DRAINAGE AND TRANSPORTATION INFORMATION SHEET

Re: Get a Grip
11840 Cochiti SE
Traffic Circulation Layout
Architect's Stamp 02-27-17 (L21-D058)

SITE PLAN

1' site plan
a 0 0 1 1' = 10'

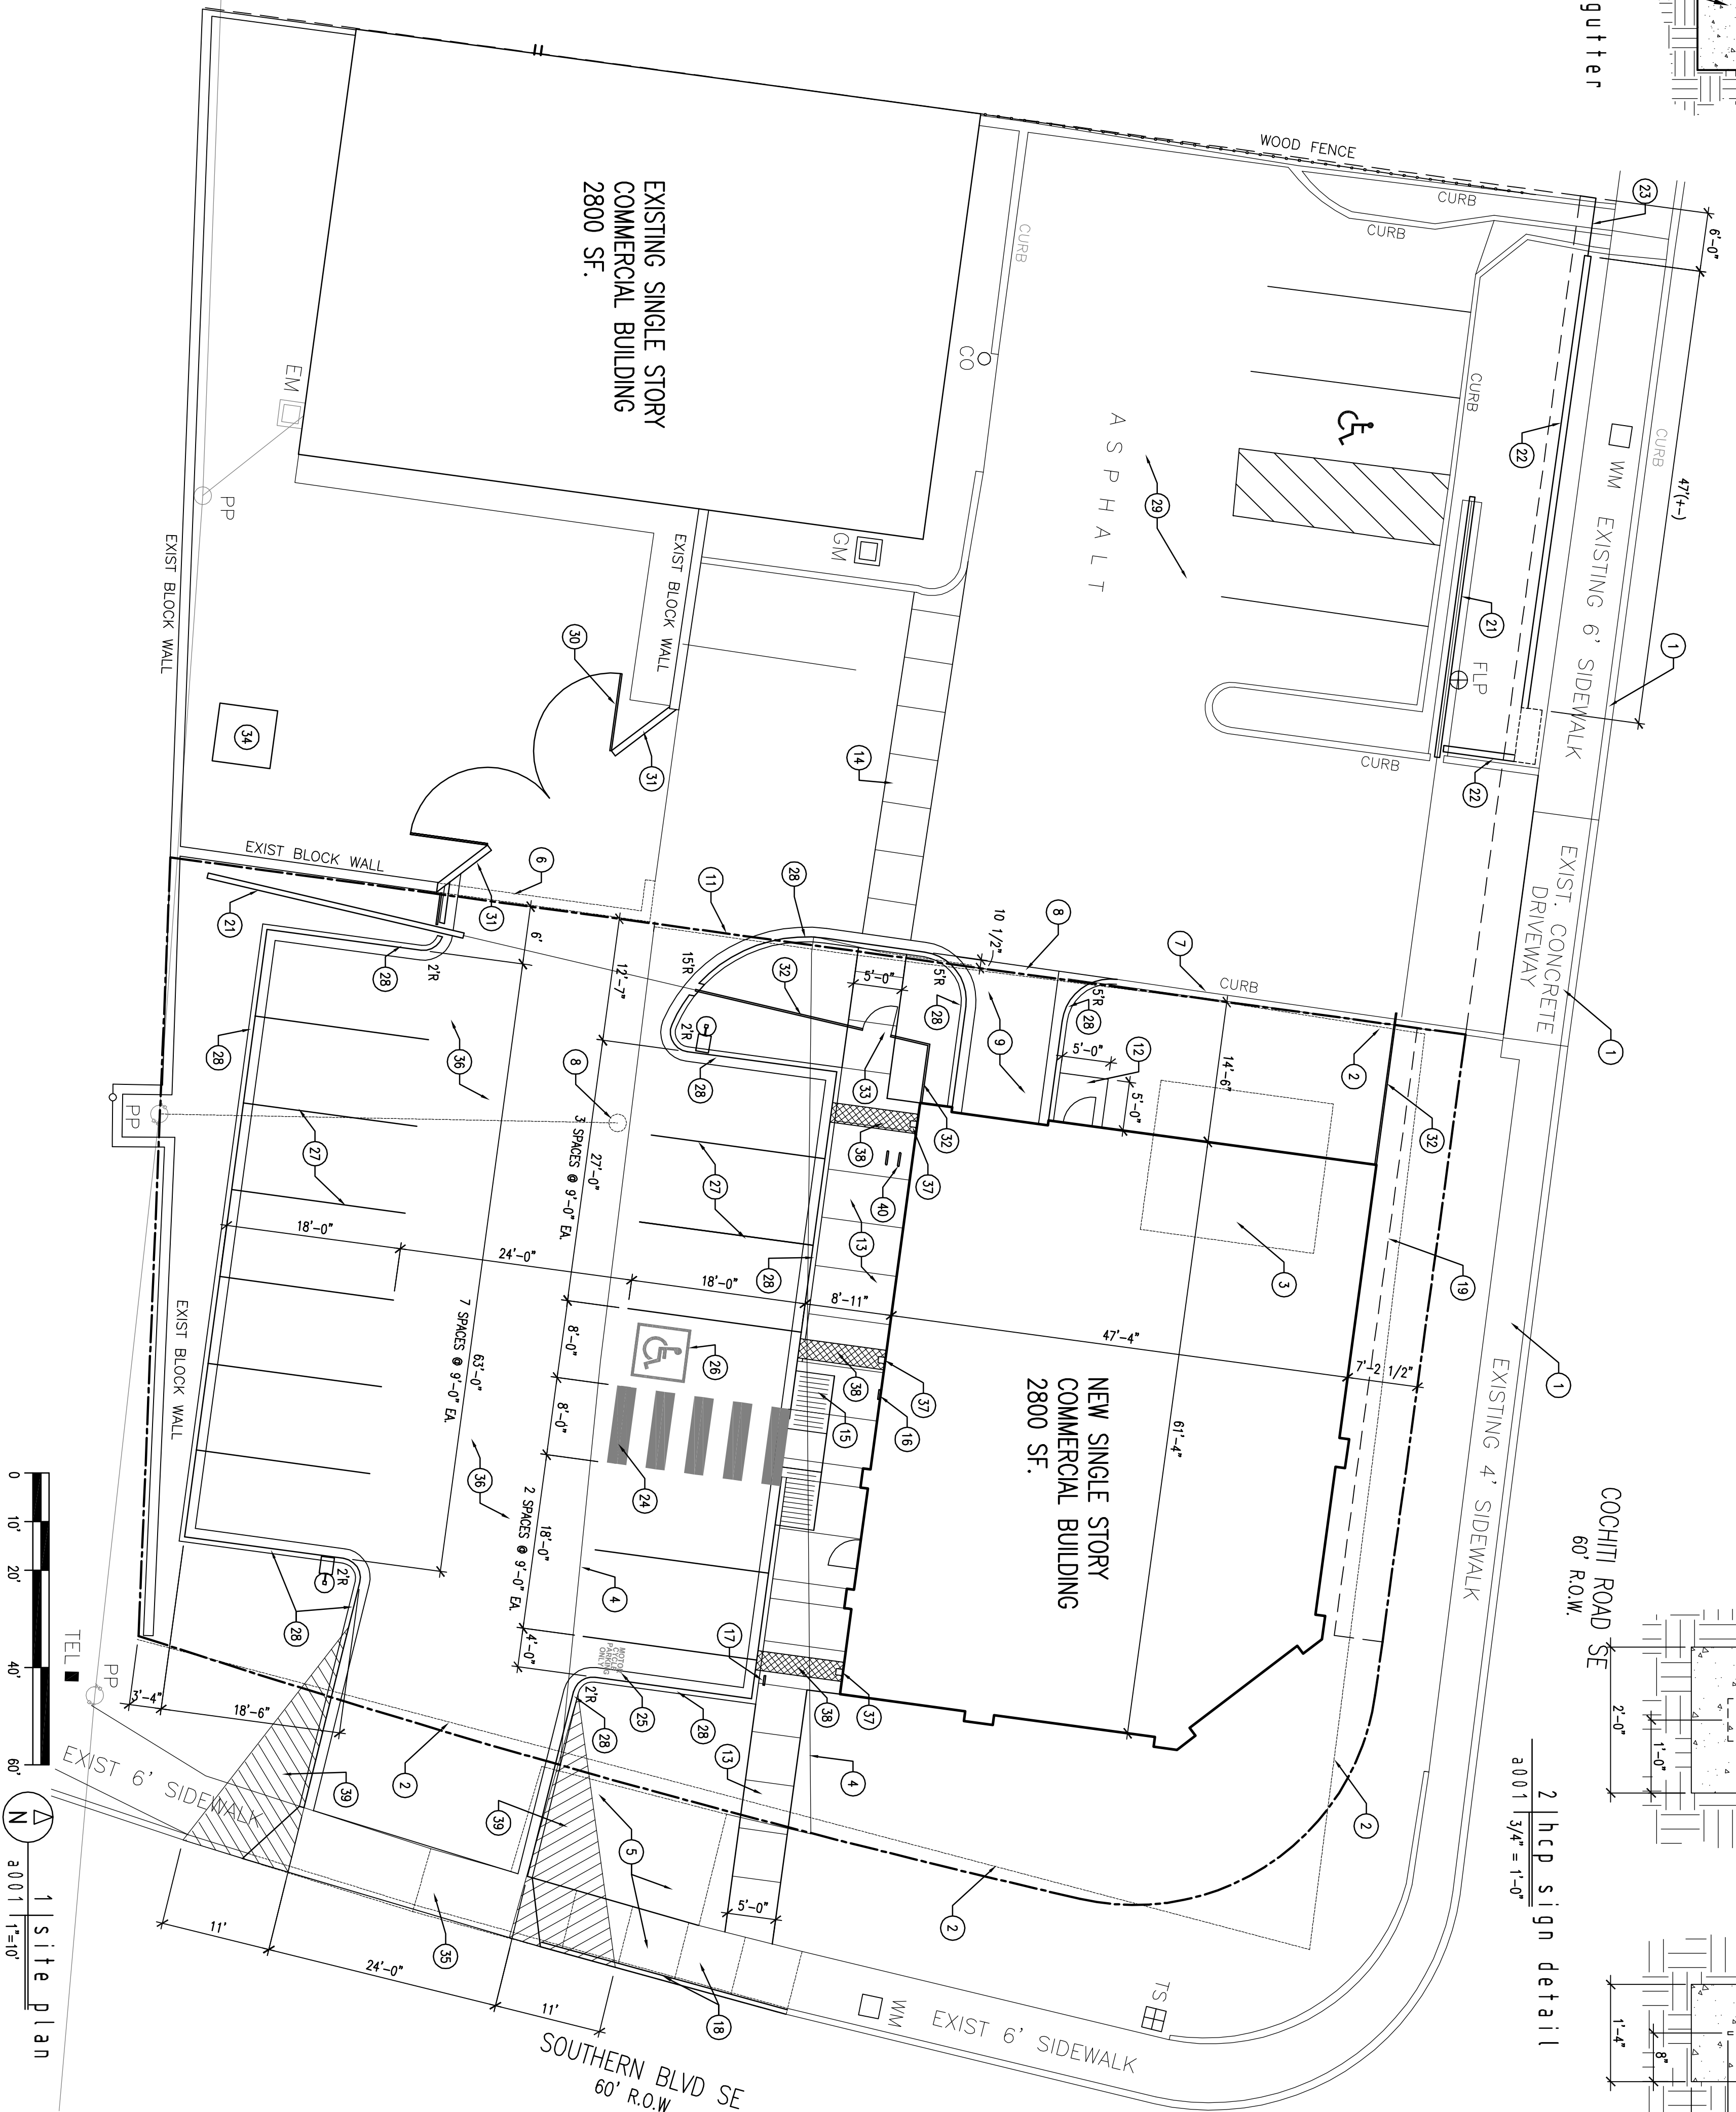
Based upon the information provided in your submittal received 02-28-17, the above referenced plan cannot be approved for Building Permit until the following comments are addressed:

1. Per the zoning code, a 6 ft. wide ADA accessible pedestrian pathway is required from the public sidewalk to the building entrances. Please clearly show this pathway and provide details.
2. Please show detail for the pedestrian path on the west side of lot. This should be ADA accessible.
3. Please specify the City Standard Drawing Number when applicable.
4. Please show dimension of existing shared driveway.
5. Please include a copy of your shared access agreement with the adjacent property owner.
6. Please include two copies of the traffic circulation layout at the next submittal.
